C F BRAUN & CO  
*Engineers*  
ALHAMBRA CALIFORNIA

August 3, 1979

PROPOSED REVISIONS  
QUALITY ASSURANCE PROGRAM  
BRAUN TOPICAL REPORT - 21A

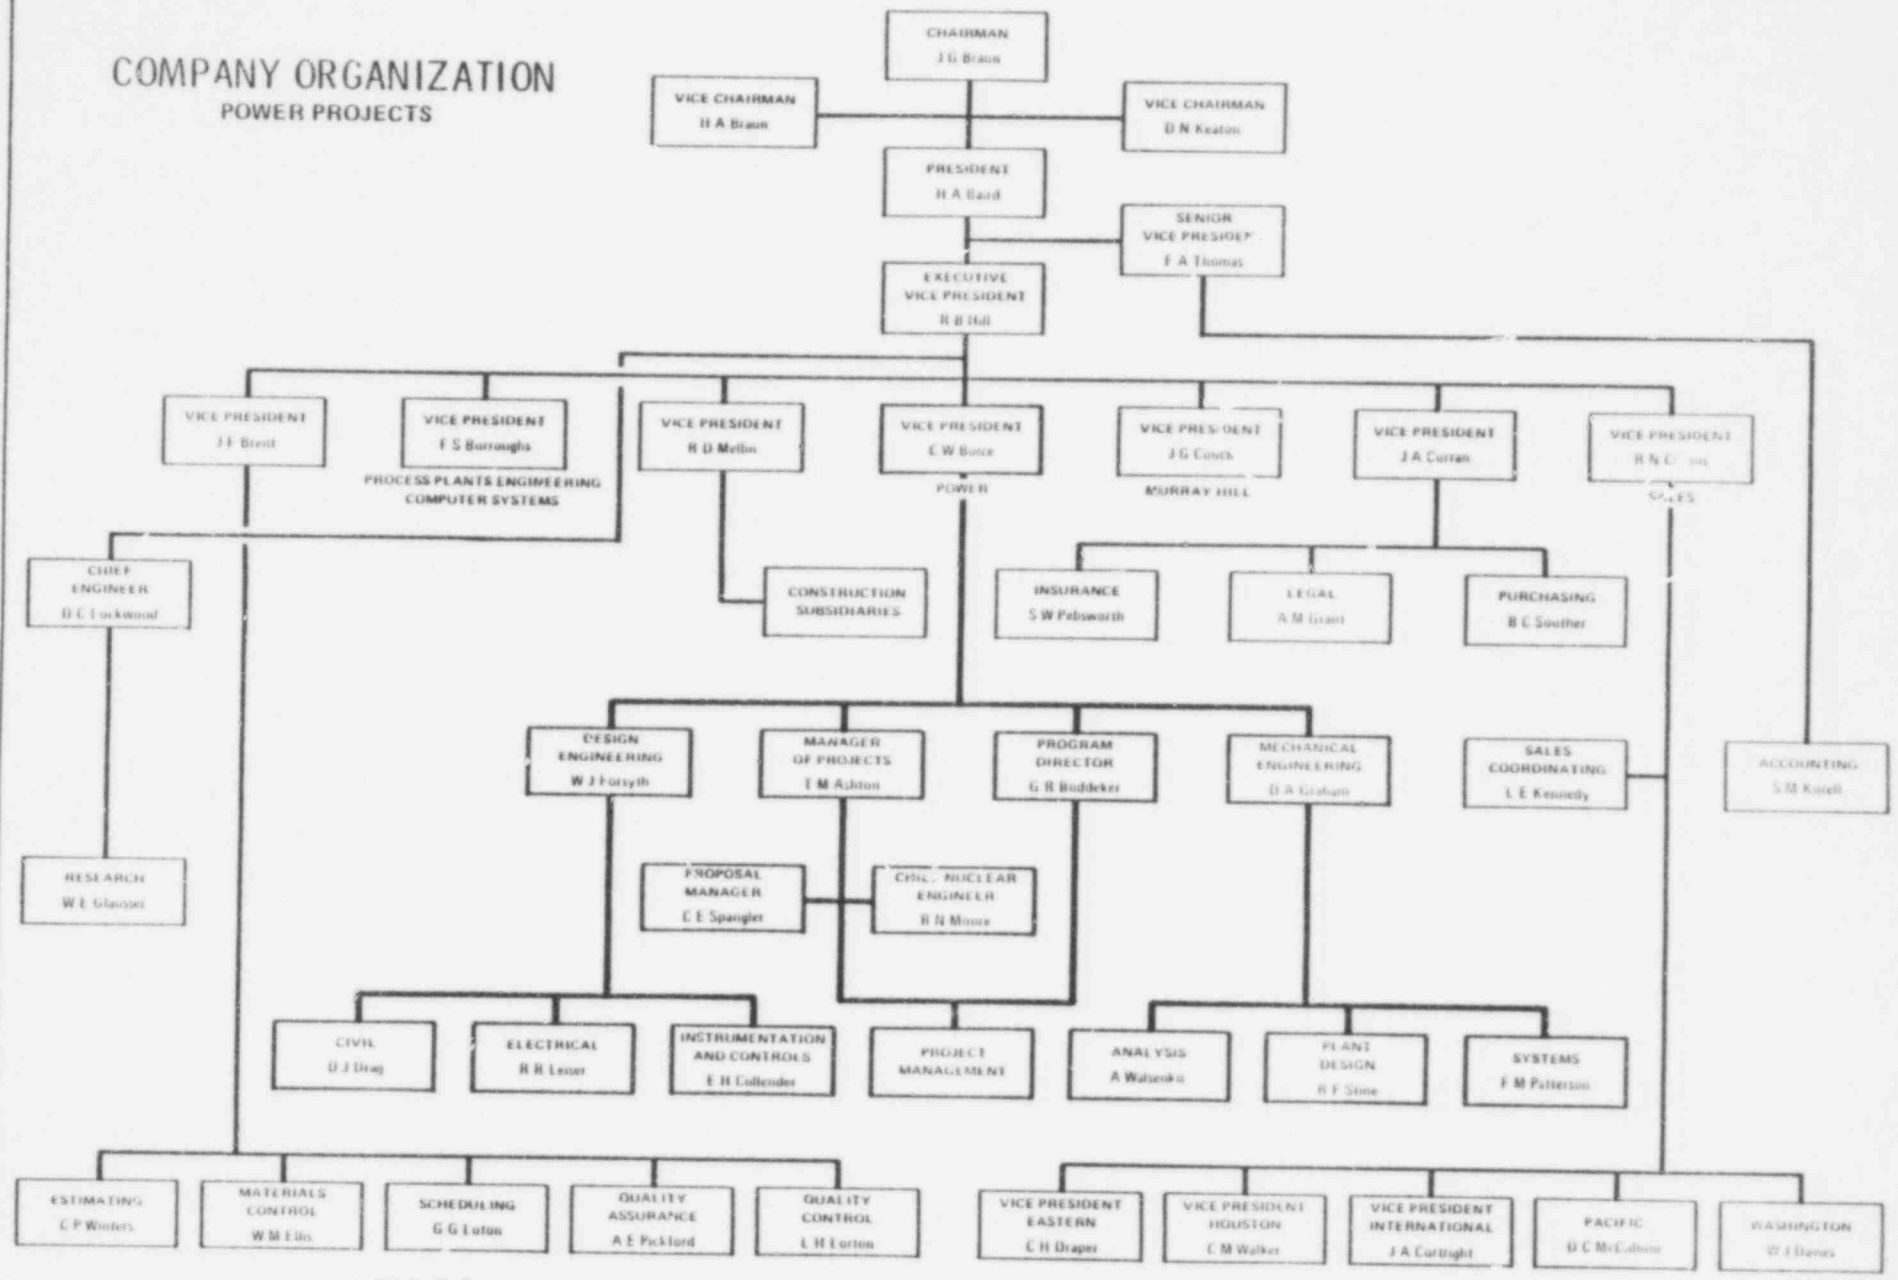
Vice Presidents responsible for controlling Braun project operations report to the Executive Vice President who reports to the President. Each Vice President is responsible for specific segments of Braun operations through organization of divisions, departments and groups. A Senior Vice President, who is responsible for financial affairs, also reports to the President. The President reports to the Chairman. The Company Organization chart is shown on Page 5.

Please note that construction work at jobsites is performed by either of two wholly owned subsidiaries, San Jacinto Construction Co or C F Braun Constructors Inc. For purposes of quality assurance the presidents of the two subsidiaries report to the Vice President for Construction of C F Braun & Co.
